Service Bulletin

No.: MZ08-004

Model: SR6001, SR7001, SR8001

Subject: Information on the addition of Service extension cable.

7. WIRING DIAGRAM

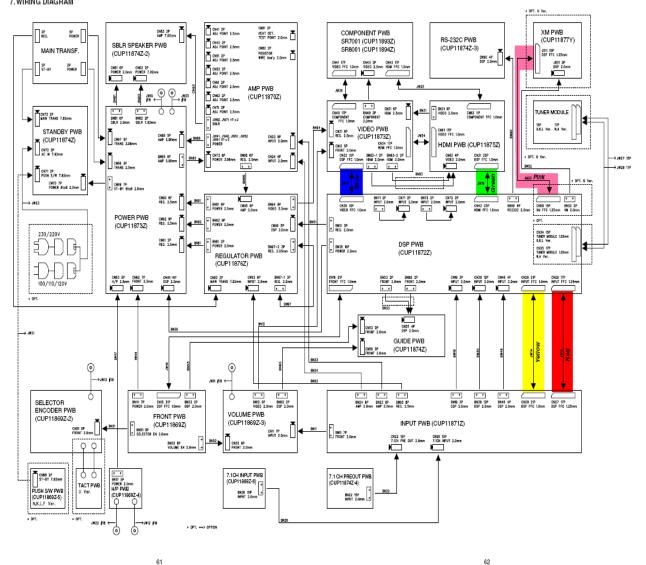
Solution: The Extension FFC comes in several types depending on the number of PINs and the length. That is why each comes marked in the same color with the location specified on the wiring diagram (below). Please check the attached wiring diagram before use.
